**August 17, 2016
ADDENDUM NO. 3:**

**Contract Documents, Project Specifications and Bid Plans For 49th Street,
Brantner Road and Industrial Parkway Project dated July 26, 2016**

See attached revised bid form, specifications and plan set pages changing the specification for hot mix asphalt from 403-34751 (PG 64-28) to 403-34741 (PG 64-22). This is the only change made by this addendum.

As Constructed	49TH/BRANTNER/INDUSTRIAL TABULATIONS		Project No./Code
No Revisions:			PW 00302 /
Revised:	Designer: D.TUTTLE	Structure Numbers	Drawing Number GN-004
Void:	Detailer: D.GONZALES	Sheet Subset: GENERAL	Subset Sheets: 4 of 6
			Sheet Number 4 of 41

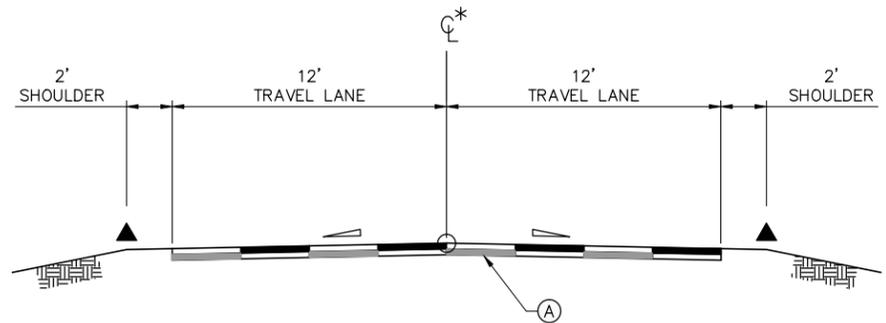
Sheet Revisions		
Date:	Comments	Init.
08/17/2016	CHANGE HMA TYPE

SURFACE ITEMS					
STATION / LOCATION	AREA (SF)	3" GRADING SX (75) (PG 64-22)	FULL DEPTH RECLAMATION OF HOT MIX ASPHALT PAVEMENT (8-12 INCH)	CONCRETE PAVEMENT (6 INCH)	AGGREGATE BASE COURSE (CLASS 6)
		TON	SY	SY	TON
49TH AND INDUSTRIAL					
STA. 14+25.00 TO 15+00.00 & 26+50.00 TO 27+50.00	4626	86			
STA. 15+00.00 TO 26+50.00	32057		3327	3562	
STA. 14+25.00 RT. TO 15+75.00 RT.	1898				63
STA. 18+50.00 LT. TO 19+00.00 LT.	892				30
STA. 20+00.00 RT. TO 24+45.00, 130' RT. (INCLUDES SHOULDER ON BRANTNER RD.)	2919				97
STA. 23+40.00 LT. TO 23+60.00 LT.	634				21
STA. 24+41.47 LT. TO 24+77.61 LT.	330				11
STA. 27+00.00 LT. TO 27+50.00 LT.	758				25
BRANTNER					
STA. 51+14.00 TO 54+50.00	10294		1153	1144	
STA. 54+50.00 TO 55+00.00	1203	22			
SUBTOTALS		108			
10% IRREGULARITIES (FOR ASPHALT ONLY)		11			
TOTAL	55611	119	4480	4706	247

As Constructed	49TH/BRANTNER/INDUSTRIAL		Project No./Code
No Revisions:	TYPICAL SECTIONS & PAVEMENT SECTIONS		PW 00302 /
Revised:	Designer: D.TUTTLE	Structure Numbers	Drawing Number GN-005
Void:	Detailer: D.GONZALES	Sheet Subset: GENERAL	Sheet Number 5 of 41
		Subset Sheets: 5 of 6

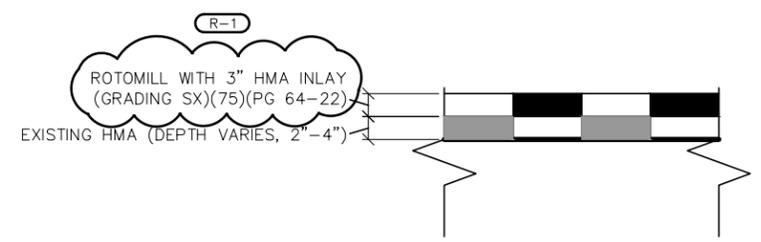
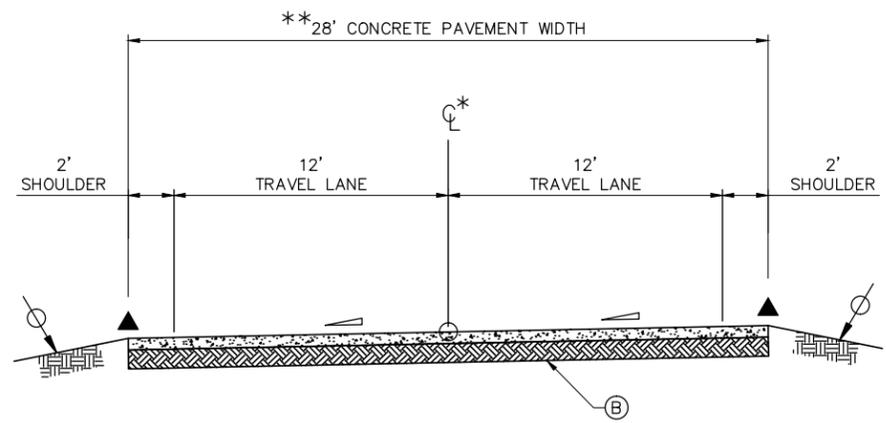
Sheet Revisions		
Date:	Comments	Init.
08/17/2016	CHANGE HMA TYPE
